**From:** John Lai  
**Sent:** Thursday, April 03, 2008 8:46 AM  
**To:** George Wunder  
**Cc:** Glenn Kelly; Hossein Hamzehee  
**Subject:** FW: Information from ABWR SSAR  
**Attachments:** 20\_03\_09.pdf

The attached file contains GE responses to the Ninth set of RAIs on the ABWR SSAR. Questions 725.43, 725.44, and 725.45 reference the transmittal of CAFTA and MAAP input files to the NRC. This is all of the additional information I have right now. I'm not sure of the dates of the RAI or the responses, although it was probably in the mid 90s.

### 20.3.9 Response to Ninth RAI — Reference 9

Figure 20.3.9-8 Water Level in Fuel Channels Following a 0.0279 m<sup>2</sup> Break in the RHR Vessel Shutdown Suction Line: 1 RHR Available

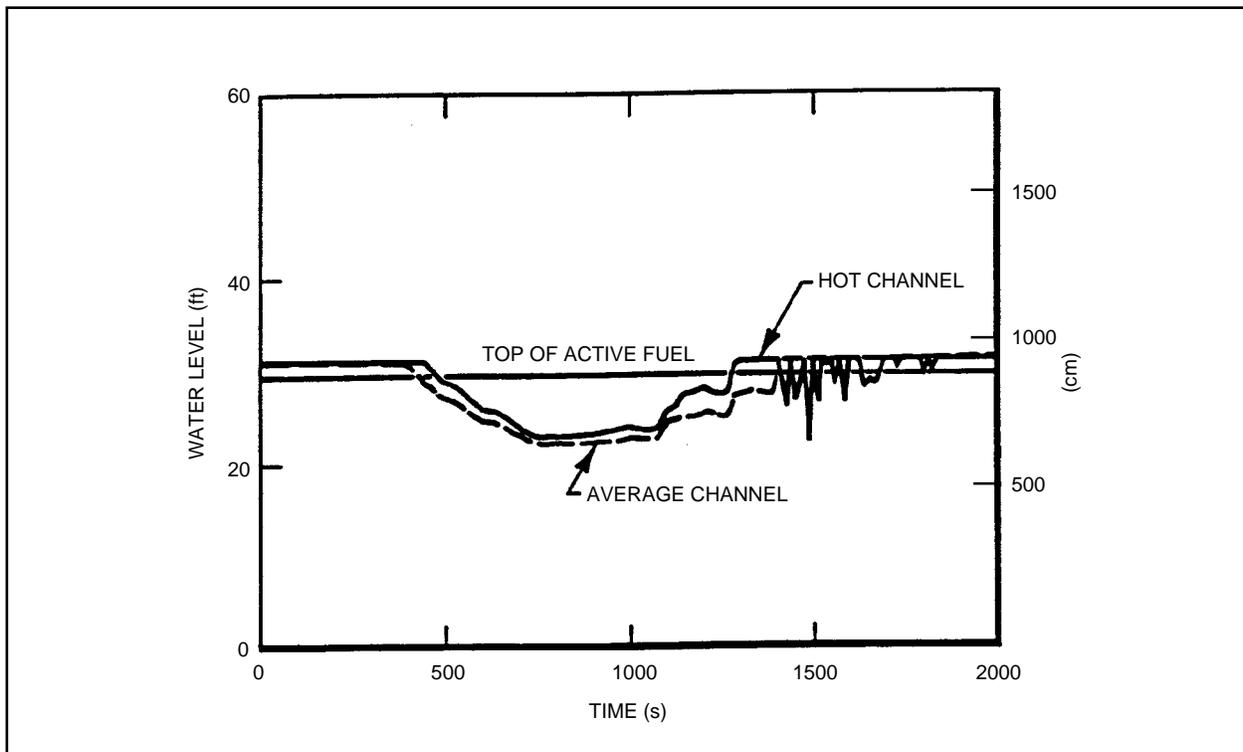
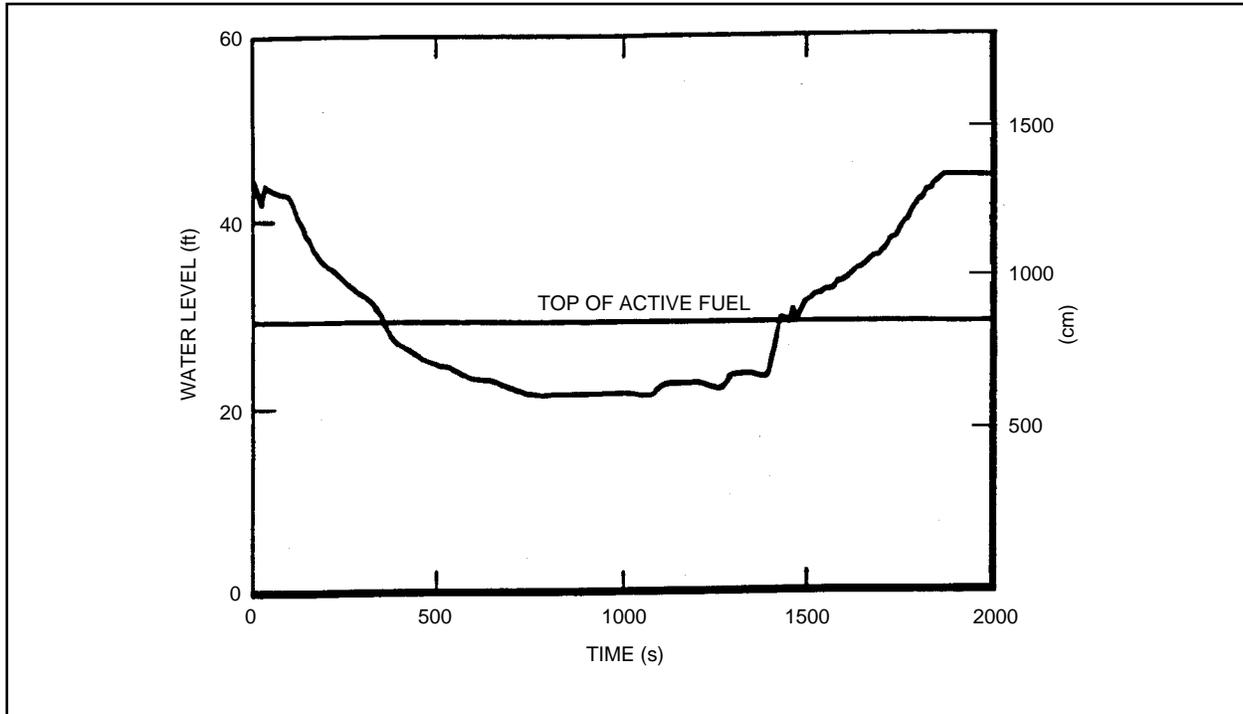
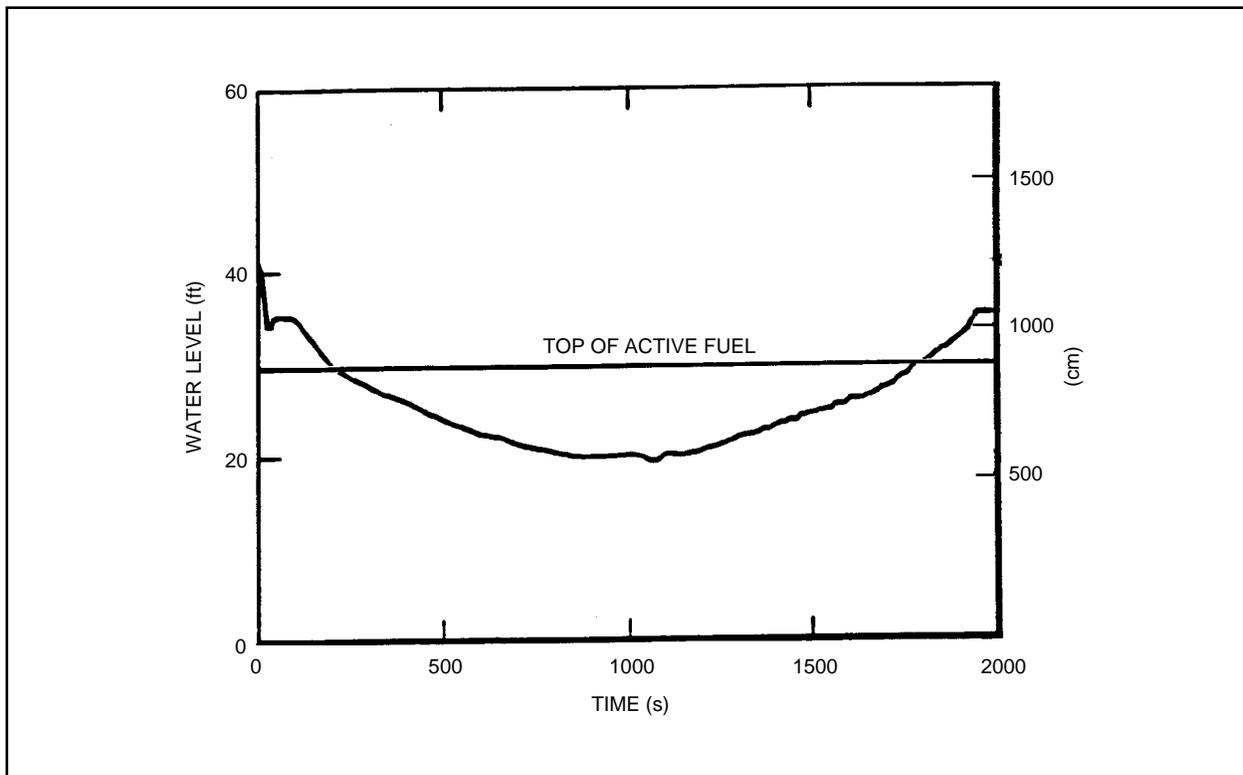
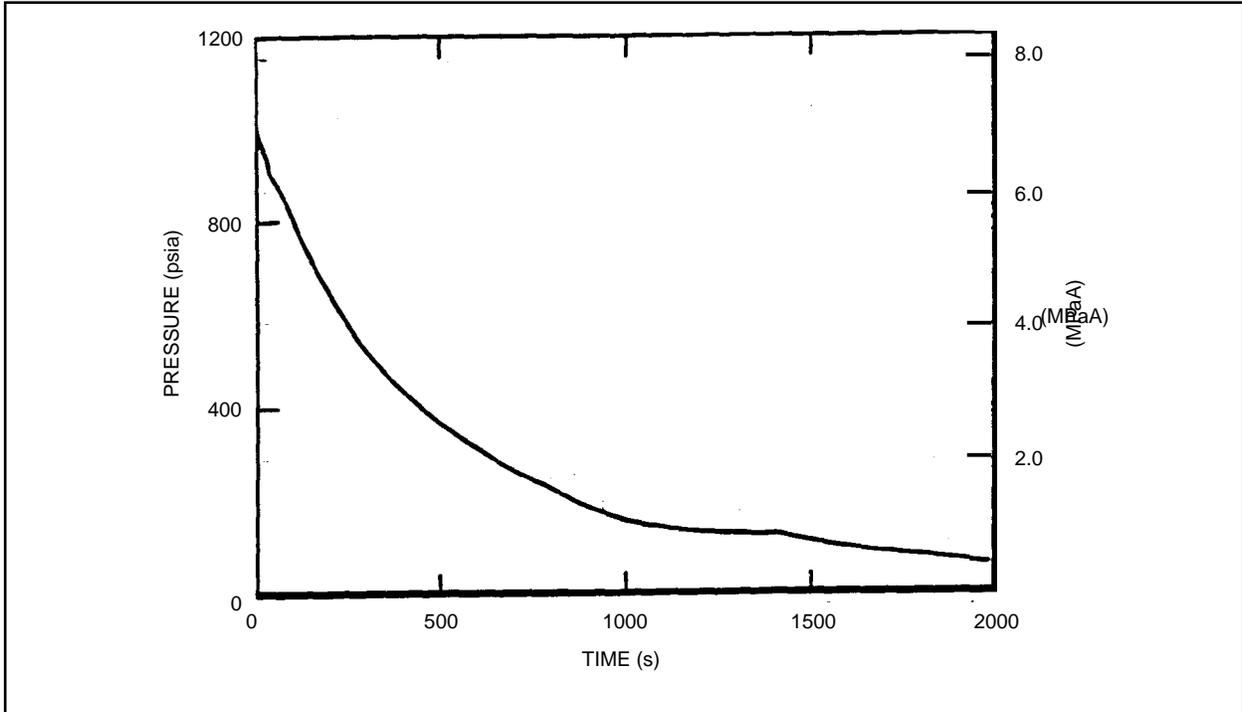
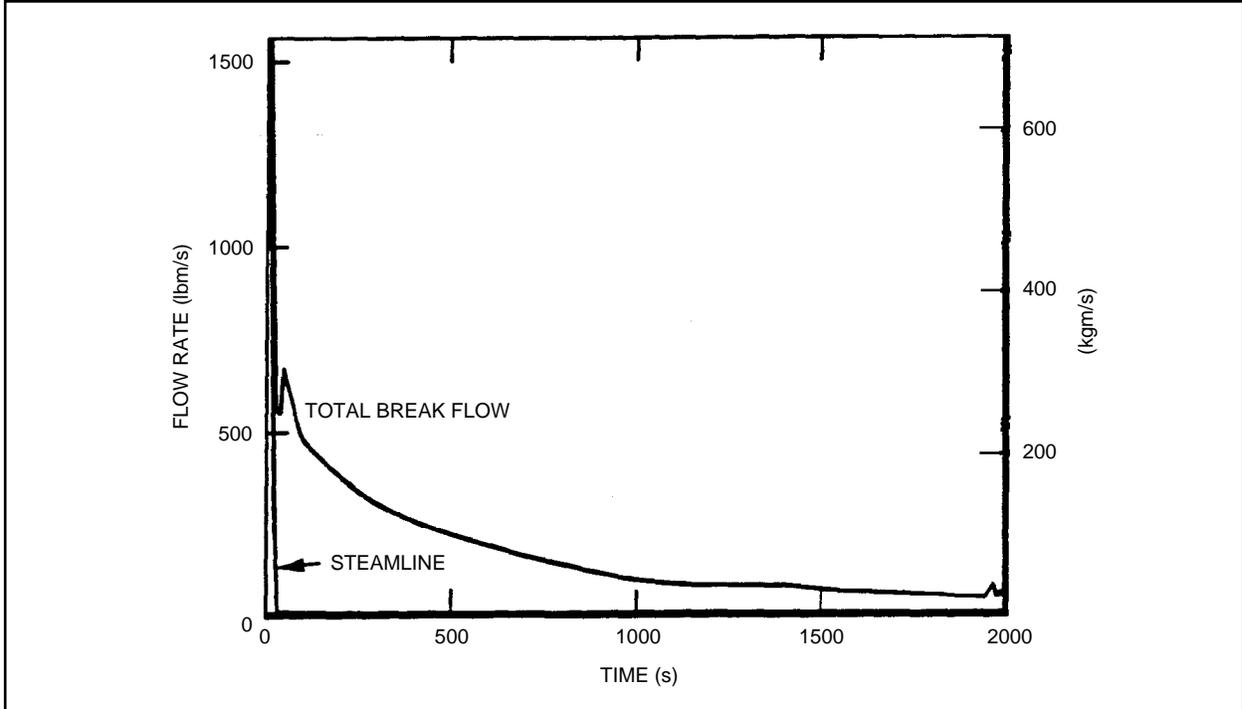
In essentially all of the event trees shown in Fig. 19D.4-1 through Fig. 19D.4-14, failure of the W function (long term heat removal) is assigned a probability of failing to run RHRA or RHRB or RHRC rather than failing to start and run RHRA or RHRB or RHRC, if the preceding V function (RHR injection or condenser) is a success. This would be correct if one of the RHR pumps was successfully started and run to accomplish the mission of the V function, and then switched to a long term heat removal mode. Notice, however that the success of the V function can also be achieved, as indicated in Table 19.3-2, by using one condenser pump and one condenser transfer pump. In such a case, the approach taken in the ABWR FSR will underestimate the failure probability of W since the RHR pump has to be started and then run throughout the mission time. Also, can one RHR pump alone always accomplish the missions of both the V and the W functions for all the transients including a large LOCA?

For large breaks, it was determined that a  $0.0279 \text{ m}^2$  break in an RHR vessel shutdown suction line was the most limiting case. This is the lowest possible break location on the

vessel for large breaks which again, results in a high break flow. The results of this break are worse than breaks with larger break areas because the RHR injection is delayed due to the relatively slow vessel depressurization through the smaller break. The LOCA analysis for this case resulted in a calculated PCT of 591.1°C. Important variables from this analysis are shown in Figures 20.3.9-8 through 20.3.9-14.

Based on the results of the above study, it was concluded that 1 RHR pump provides sufficient core cooling for large breaks, and also for small and medium breaks with the equivalent of at least 3 ADS valves available.

Figure 20.3.9-15 Reactor Water Cleanup System (Response to Question 725.32)

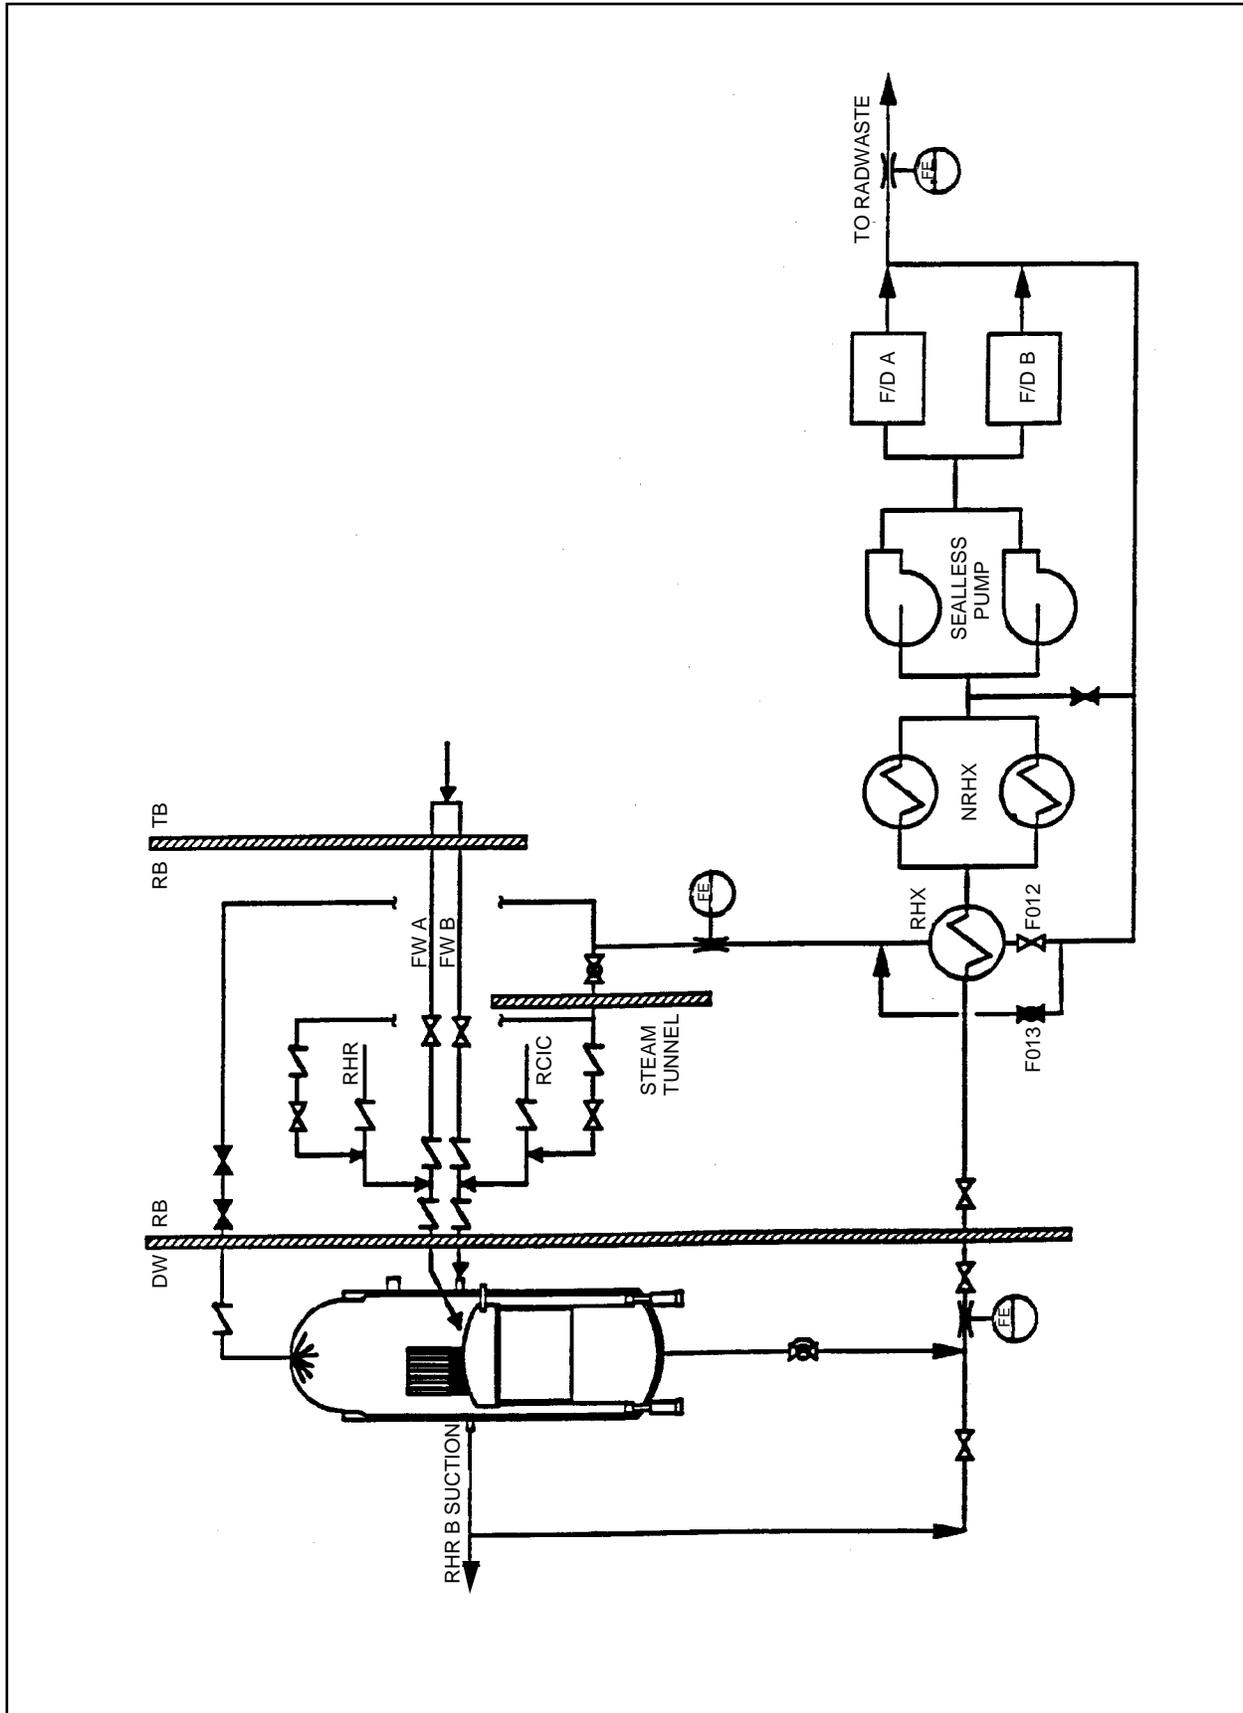
How does the RWCU (reactor water cleanup) system work to remove decay heat? What suction lines are used? What is the heat sink? Does the non-generative heat exchanger have enough capacity to remove decay heat?

Figure 20.3.9-15 is a schematic of the reactor water cleanup (RWCU) system. During normal operation, the RWCU takes suction from both the vessel bottom head drain line and the residual heat removal system B suction line. The flow passes through the

Calculations for the success criteria assume that the RWCU heat removal capability is maximized by having the return flow from the filter-demineralizers bypass the RHX. This is accomplished by closing valve F012 and opening valve F013 (refer to Figure 20.3.9-15). In this configuration, decay heat is transferred by the NRHXs from the vessel to the reactor building cooling water system and then to the reactor service water system which is the ultimate heat sink. The success criteria calculations for this case show that if the reactor system is maintained at high pressure, the RWCU can remove all the decay heat generated in the core at any time greater than 4 hours after scram.
